**LPR
APPROVED**

SOUTH ELEVATION

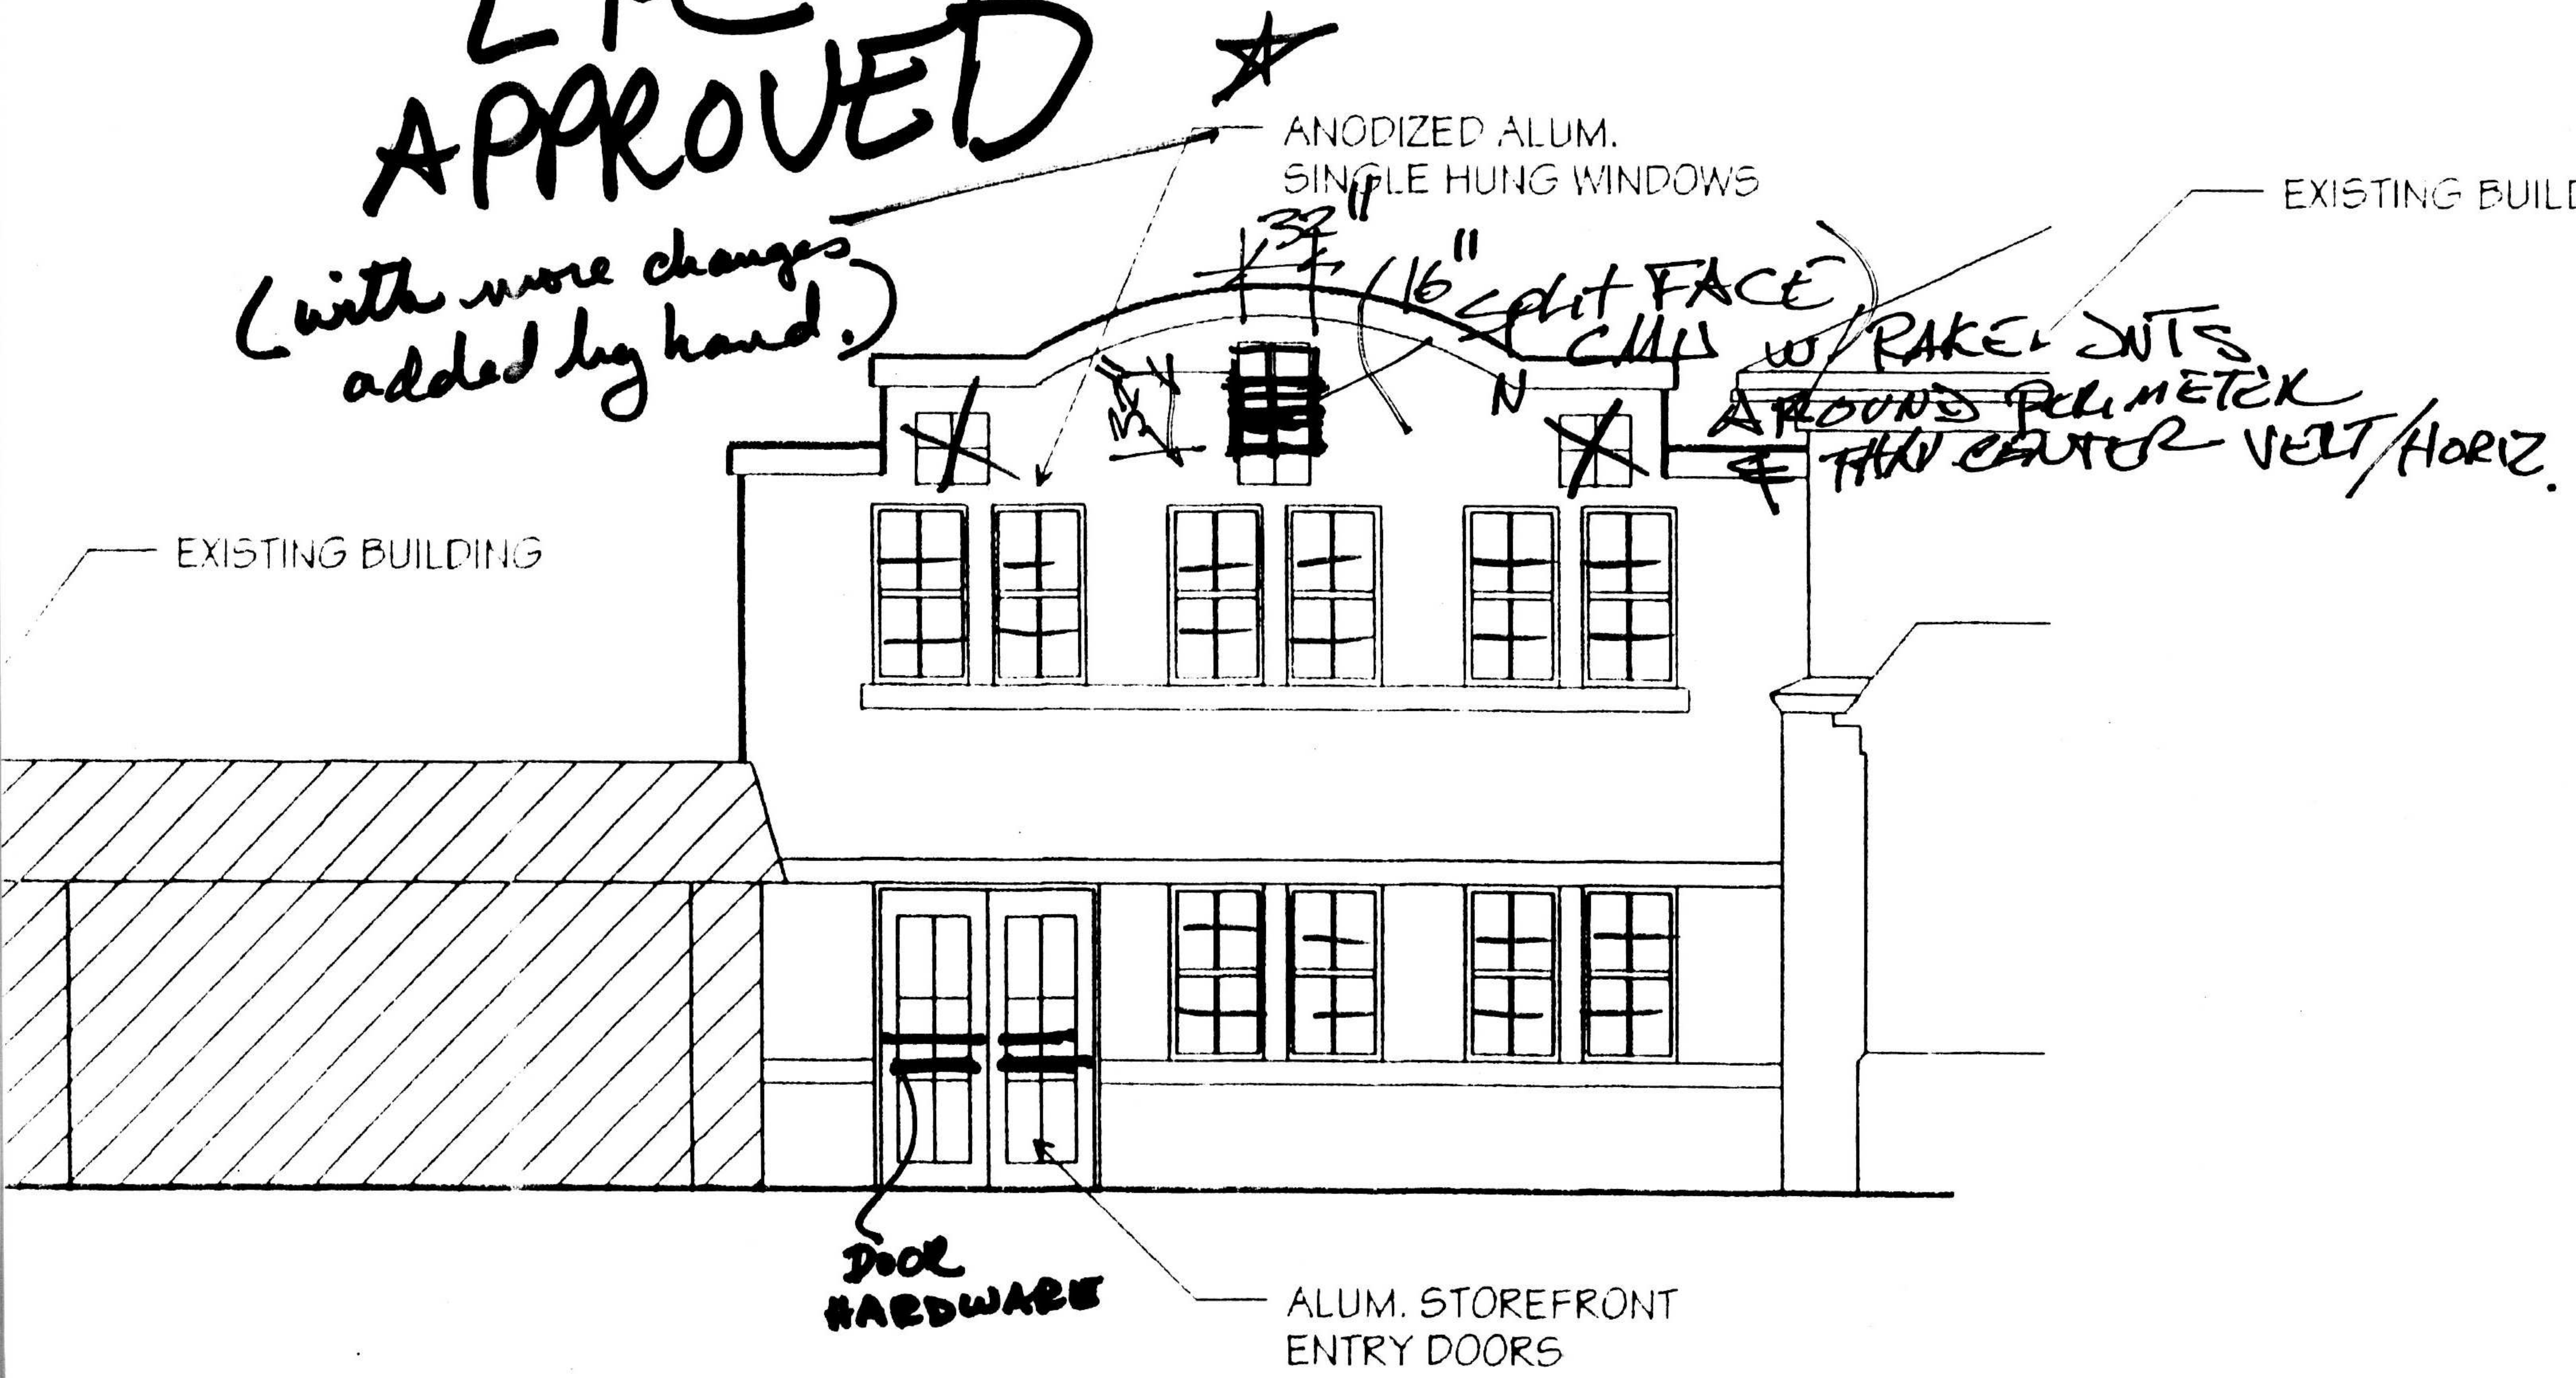
- order to make for handicapped accessibility.
2. The building addition's height is also necessary because of the internal requirement of mechanical/services not found in the front building, and to avoid having to install ramping on the second floor interiors.
 3. The historic building's roofline is a plain boxed cornice, of post World War II design.
 4. The roofline overlap will only impact the north one-third of the historic building. From the south, you will still see the historic roofline.
 5. The impact is on the rear of the historic building.

*(with more changes
added by hand.)*
